Urban Design Changes

Pearl Lofts

12.14.21

Garage Screening

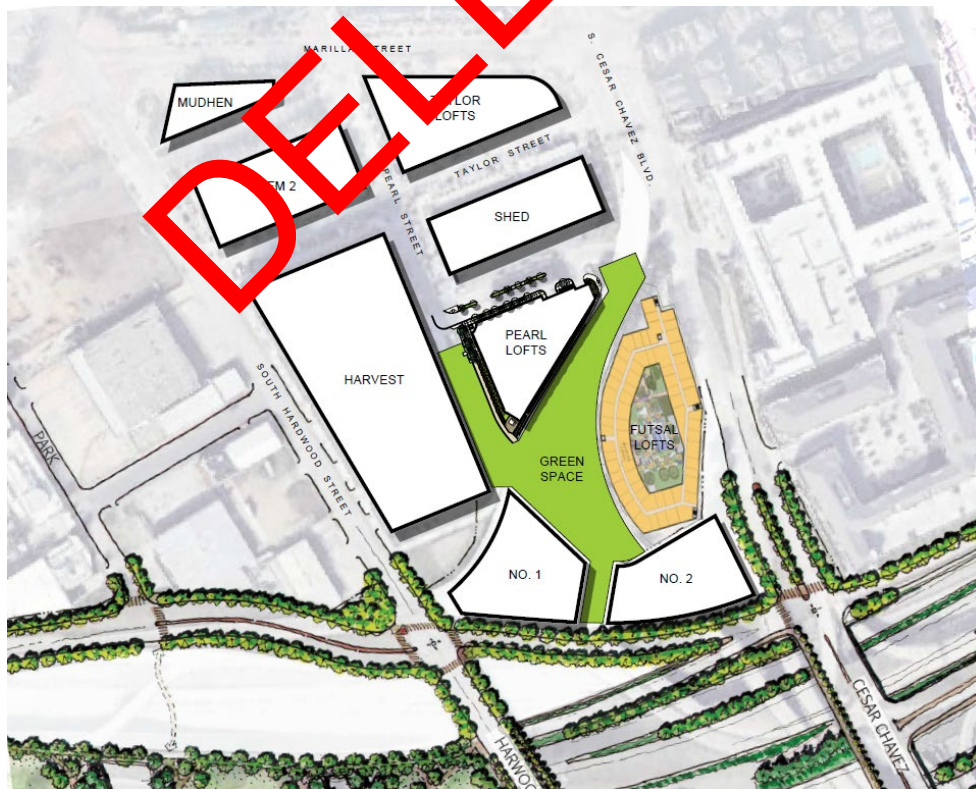
7. The Panel suggests further design refinement be given to the design of the parking garage façade on all sides to further screen the parking uses and improve the proportionality between openings on the First and Second floors.

5. The Panel notes a lack of notable change in the garage façade design facing Pearl Street and Jan Pruitt Way, highlighting the need to better reflect recommended changes noted in the first review.

- As noted in both reviews, the UDPRP was particularly concerned about the screening of the garage on the first and second level. On Page 3, the before and afters of the garage are shown.

Before: Garage was not screened on the rear, and along Pearl Street ROW and Jan Pruitt Way, it was not reflective of the remainder of the façade on the front of the building

After: A green/vegetated screening wall was added to the rear façade to soften the edge in the interim and better interact with a future open space. Additional façade enhancements were added on the other garage facades to better screen the parking.

Relation with Future TXDOT Improvements

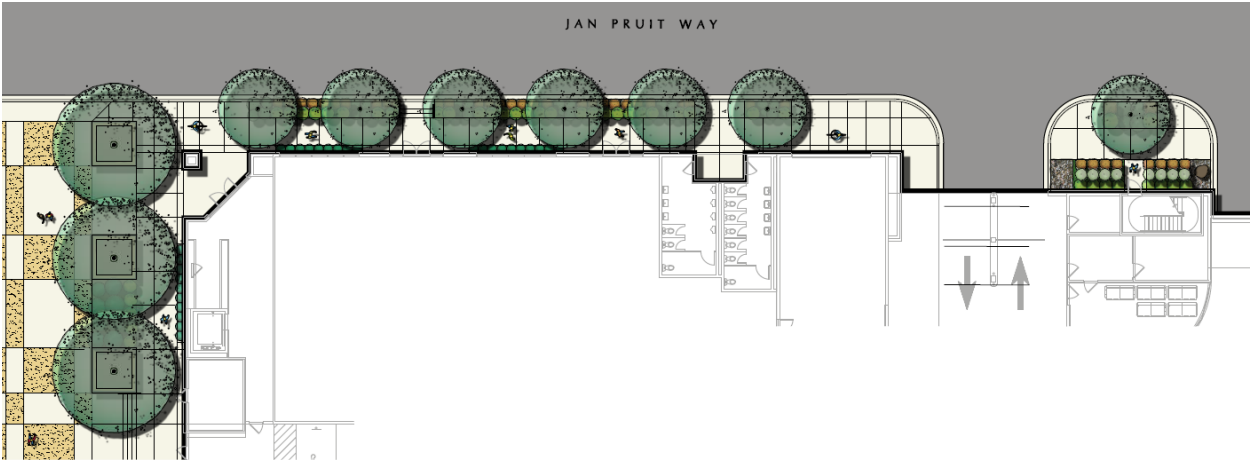
2. The Panel recommends that more thought be given to the way this development interfaces with the removal of Cesar Chavez, including providing a potential Phase II diagram. Another possibility is a future extension of the proposed garage to allow for new retail/office along the Pearl Street frontage.

- As a part of the second review, the Panel advised the development team better consider ways in which this development could be thought of as part of future development which could occur as a result of the reconstruction of I-30 and the freeing up of City and TXDOT right-of-way. The development team provided a diagram highlighting what that might look like in the future.

Before: Initial site plan

After: Diagram showing how Pearl Lofts might interface with new developable property
